# HISTORIC AND DESIGN REVIEW COMMISSION

August 21, 2024

**HDRC CASE NO:** 2024-246  
**ADDRESS:** 325 E LOCUST  
**LEGAL DESCRIPTION:** NCB 1738 BLK 3 LOT 6  
**ZONING:** MF-33  
**CITY COUNCIL DIST.:** 1  
**DISTRICT:** Tobin Hill Historic District  
**APPLICANT:** RICARDO MCCULLOUGH/MCCULLOUGH DESIGN ASSOCIATES  
**OWNER:** RAUL OSIO/TOBIN HILL DEVELOPMENTS LLC  
**TYPE OF WORK:** Additions and alterations  
**APPLICATION RECEIVED:** July 03, 2024  
**60-DAY REVIEW:** September 1, 2024  
**CASE MANAGER:** Bryan Morales

**EXISTING LEFT ELEVATION**  
SCALE: 3/16" = 1'-0"

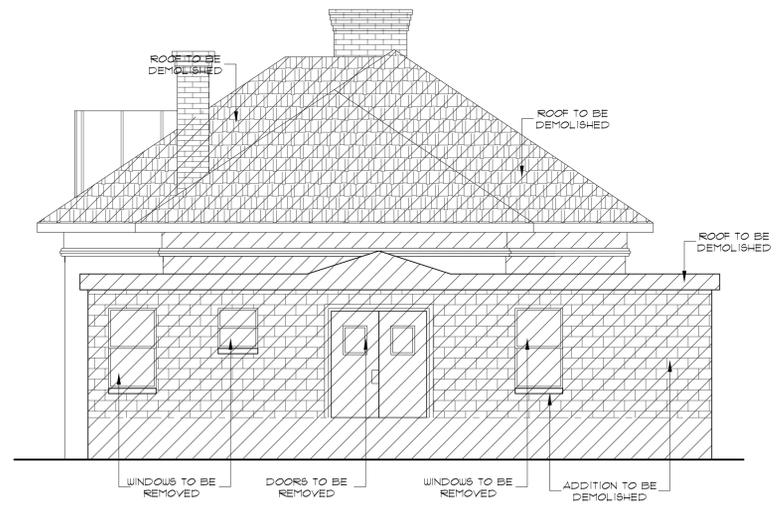
- f. PARTIAL DEMOLITION OF REAR ADDITION – The applicant is requesting approval to remove the existing CMU rear addition. This section of the structure first appears on the 1973 Historic Aerials map. Staff finds the demolition of the CMU rear addition generally conforms to the UDC.

**PROPOSED AERIAL VIEW**

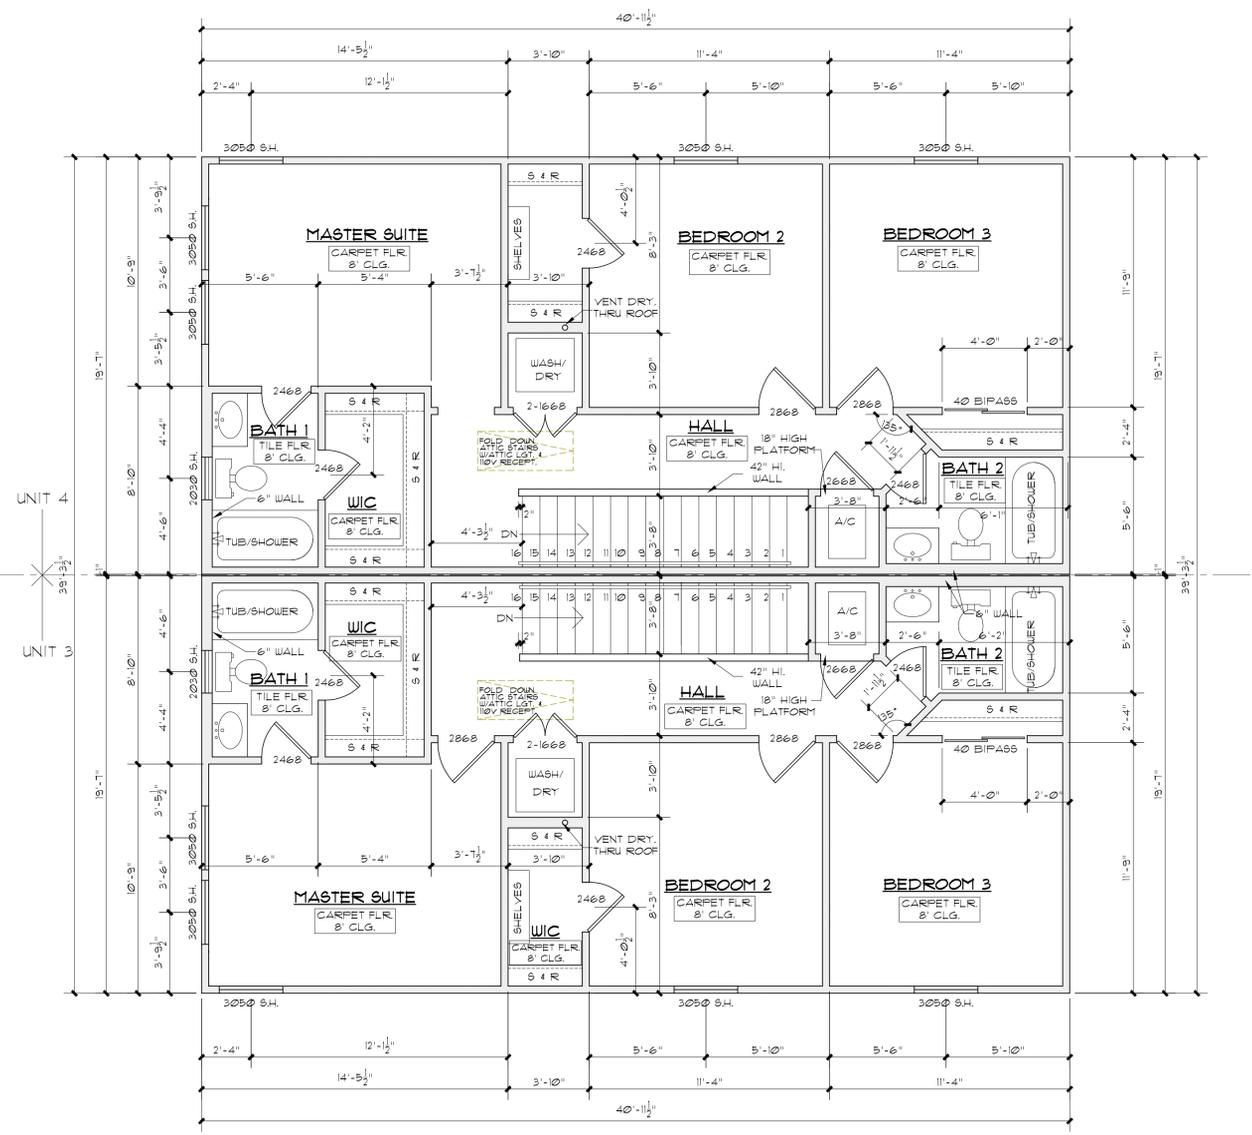
- s. **ROOF FORM & MATERIALS MODIFICATIONS** – The applicant is requesting approval to modify the existing front-facing dormer. Additionally, the applicant is requesting approval to remove the existing decorative pressed-tin metal roof and replace with a standing seam metal roof where present. The applicant’s submitted construction documents show the removal of the front-facing dormer on the proposed side elevations and other inconsistencies between the elevation drawings. Exterior Maintenance and Alterations 3.B.ii. states to preserve the original shape, line, pitch, and overhang of historic roofs when replacement is necessary. Exterior Maintenance and Alterations

- 3.B.iii. states to preserve and repair distinctive roof features such as cornices, parapets, dormers, open eaves with exposed rafters and decorative or plain rafter tails, flared eaves or decorative purlins, and brackets with shaped ends. Exterior Maintenance and Alterations 3.B.iv. stipulates to replace roofing materials in-kind whenever possible when the roof must be replaced and to match new roofing materials to the original materials in terms of their scale, color, texture, profile, and style, or select materials consistent with the building style, when in-kind replacement is not possible. Staff finds the proposed front-facing dormer removal does not conform to Guidelines. While the proposed replacement roof conforms to the standing seam metal roof stipulations found in Chapter 2, Exterior Maintenance and Alterations, staff finds that the proposed standing seam metal roof does not conform with Guidelines as it constitutes a change in material, texture, and style, where the decorative pressed-tin metal roof is present.

**PROPOSED LEFT ELEVATION**  
SCALE: 3/16" = 1'-0"

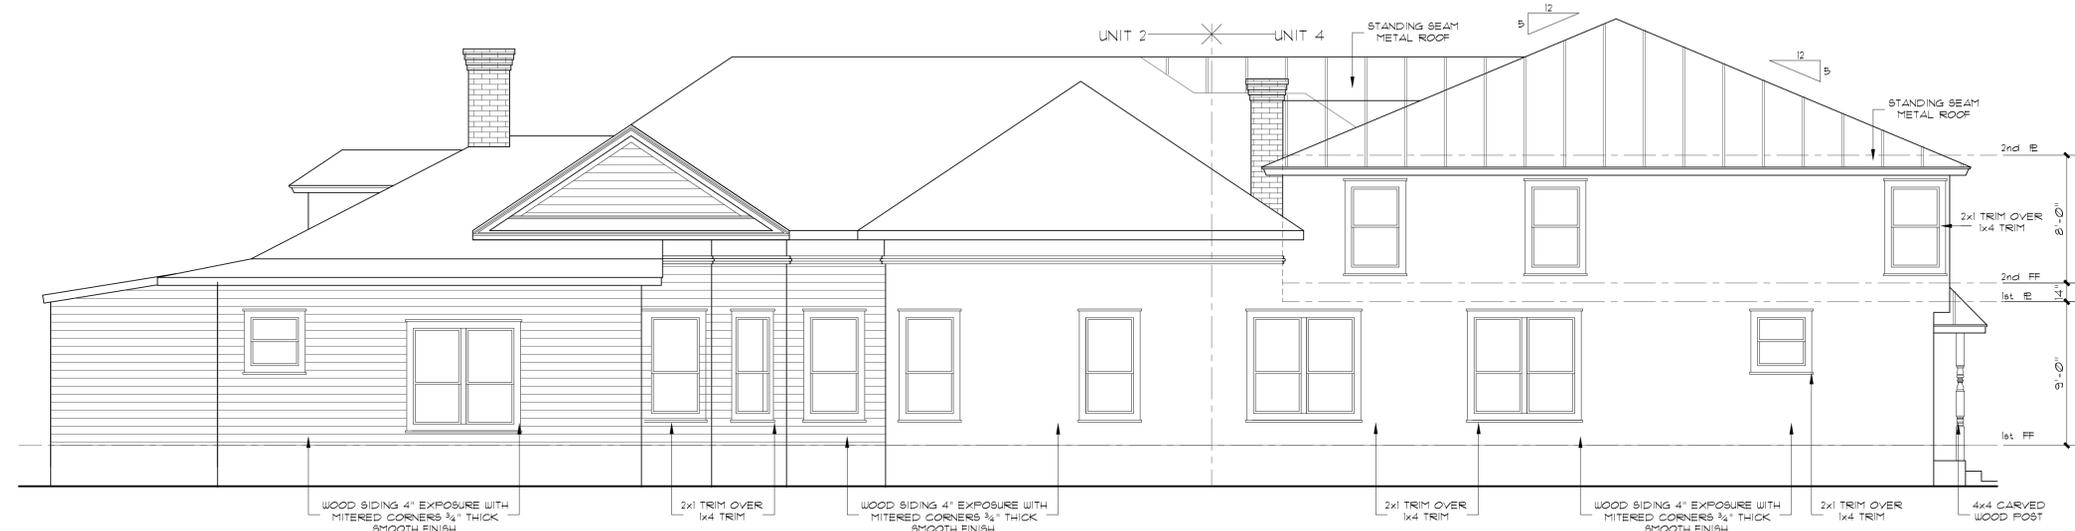
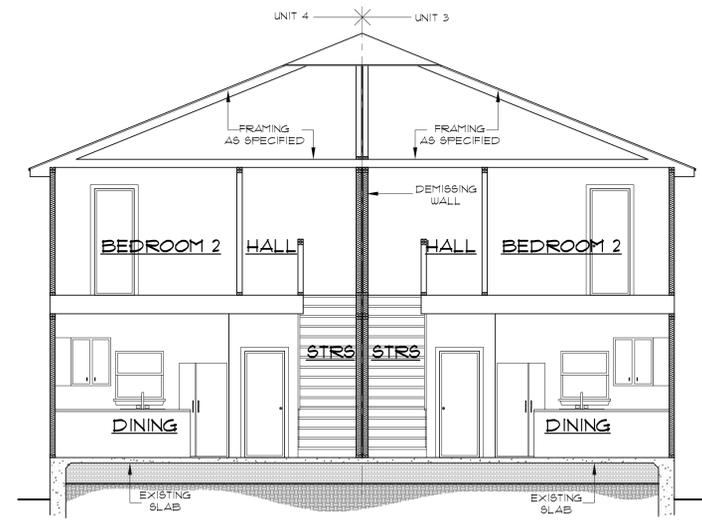
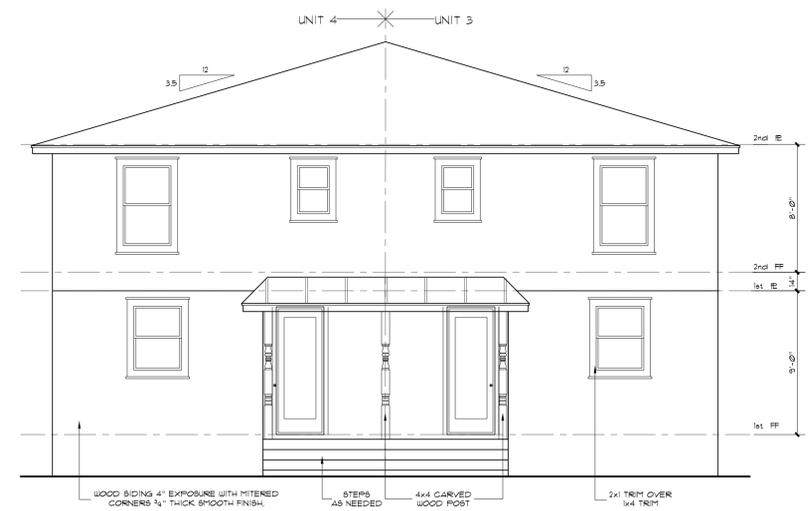
- o. **TWO-STORY REAR ADDITION (ARCHITECTURAL DETAILS)** – The applicant has proposed to construct a two-story rear addition. Additions 4.A.ii states additions should incorporate architectural details that are in keeping with the architectural style of the original structure. Details should be simple in design and compliment the character of the original structure. Architectural details that are more ornate or elaborate than those found on the original structure should not be used to avoid drawing undue attention to the addition. Additions 4.A.iii states applicants should consider integrating contemporary interpretations of traditional designs and details for additions. Use of contemporary window moldings and door surroundings, for example, can provide visual interest while helping to convey the fact that the addition is new. Additions 2.A.v recommends that for side or rear additions utilize setbacks, a small change in detailing, or a recessed area at the seam of the historic structure and new addition to provide a clear visual distinction between old and new building forms. Staff finds the proposed architectural details of the two-story rear addition generally appropriate.
